MANDATORY UPDATE INFORMATION

Date: 12/10/18
To: STXDF Ride-On Trowel Owners
From: Multiquip Product Department
Subject: Spider and Trunnion Fastening Bolts — **Mandatory Update**

STXDF Spider and Trunnion Bolt Replacement

Product Group: Ride-On Trowels	Date Issued: 12/10/18	Expiration Date: 12/10/19	Service Bulletin No. TR20181128
Bulletin Type <input checked="" type="checkbox"/> Mandatory <input type="checkbox"/> Information Only <input type="checkbox"/> Recommended Change		Models/Series Affected: STXDF S/N MK2004008 AND BELOW

Figure 1. Replacement Bolts and Loctite®

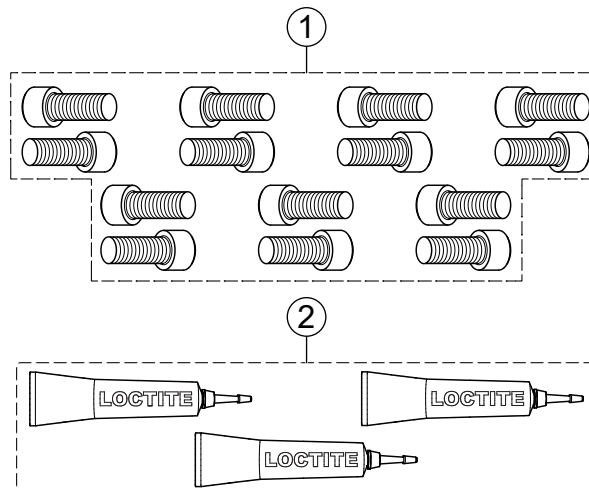
Existing bolts on both spider assemblies and left-side trunnion may self-loosen due to oil on the bolts.

Replace existing left- and right-side spider assembly bolts and left-side trunnion bolts with new zinc-plated bolts to allow thread-locking fluid to properly set.

Item	Part No.	Description	Qty.	Remarks
1	939654	Screw, SHC M12-1.75 x 30 mm 12.9	14	
2	1477	Loctite #242 Blue 0.5 cc Bottle	3

Figure 6. Remove Left-Side Trunnion Bolt

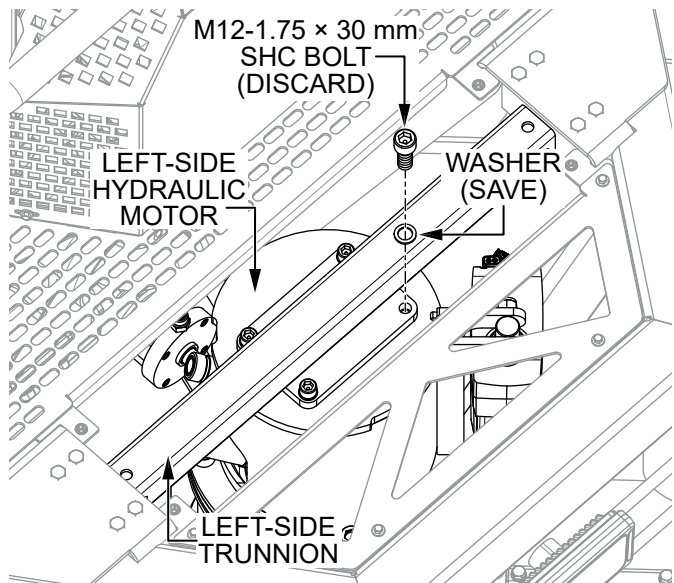
1. Remove **one** of the existing M12-1.75 × 30 mm SHC bolts (Figure 6) securing the left-side trunnion to the top of the left-side hydraulic motor. Discard the bolt but save the washer for later.

Figure 9. Install New Bolt with Existing Washer

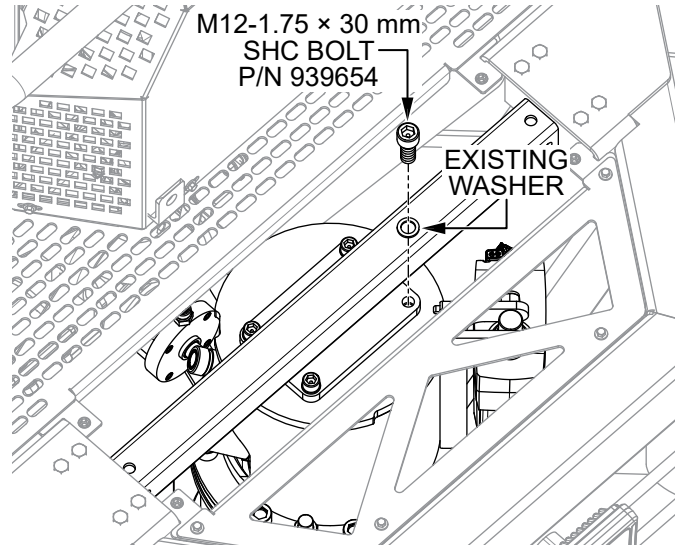
- Install the new M12-1.75 × 30 mm SHC bolt (P/N 939654) and existing washer as shown in Figure 9. Torque to 40 lbf-ft.

Figure 11. Torque Sequence

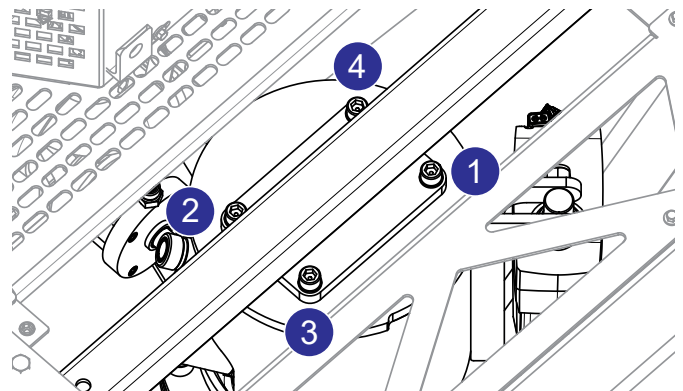
- Re-torque all four M12-1.75 × 30 mm SHC bolts (P/N 939654) to 75 lbf-ft in the sequence shown in Figure 11.

Figure 13. Remove Left-Side Spider Bolt

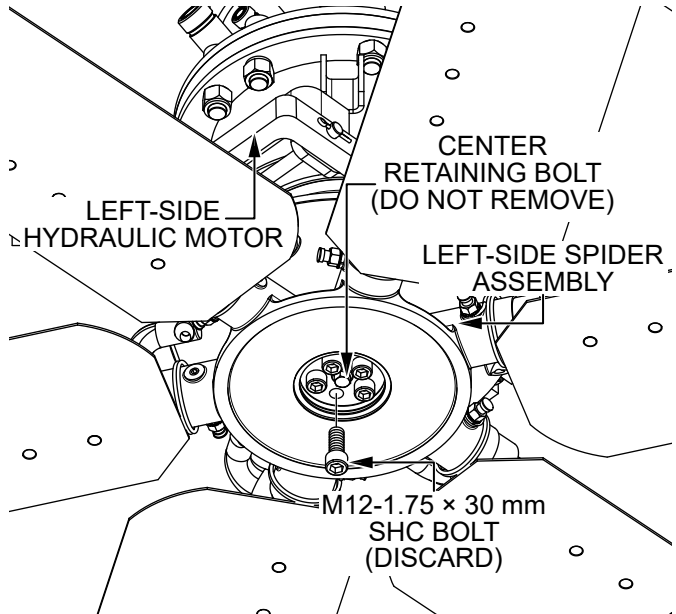
2. Remove and discard **one** of the existing M12-1.75 x 30 mm SHC bolts (Figure 13) securing the left-side spider assembly to the bottom of the left-side hydraulic motor.

DO NOT remove the center retaining bolt (hex flange type) from the spider assembly. Only the 5 surrounding screws (with socket head caps) are to be replaced.

Figure 16. Install New Bolt (Spider)

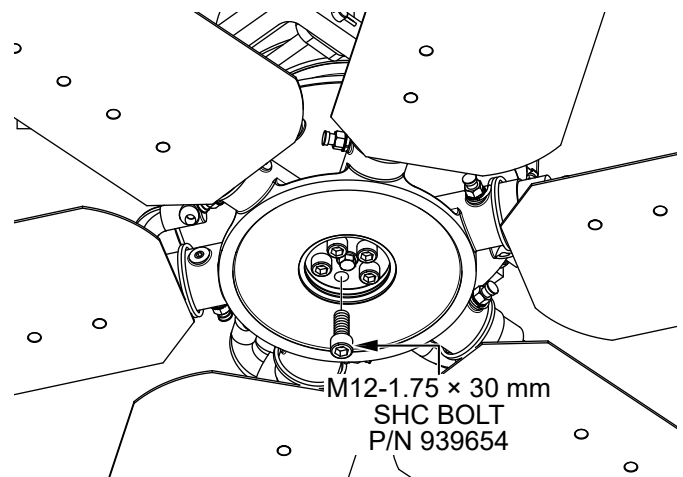
- Install the new M12-1.75 × 30 mm SHC bolt (P/N 939654) as shown in Figure 16. Torque to 40 lbf-ft.

Figure 17. Replace 4 Remaining Spider Bolts

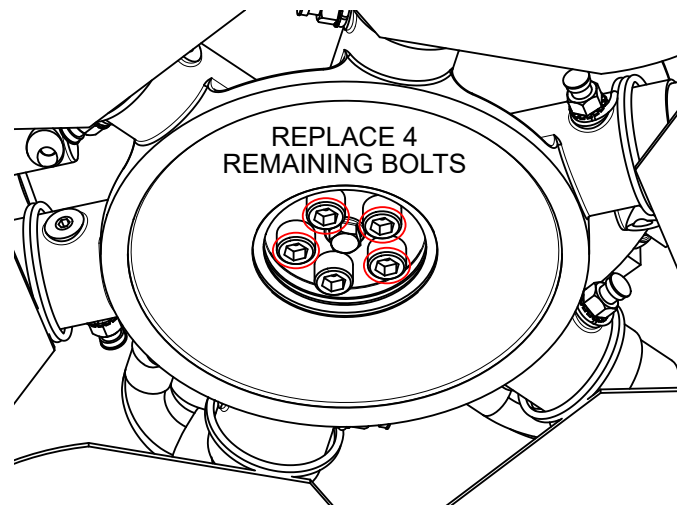
- Repeat steps 2–6 for each of the four remaining left-side spider assembly bolts (Figure 17).

- Re-torque all five M12-1.75 × 30 mm SHC bolts (P/N 939654) to 90 lbf-ft in a star pattern.
- Reinstall the left-side spider hub cap plug.
- Repeat steps 1–9 on the right-side spider assembly.
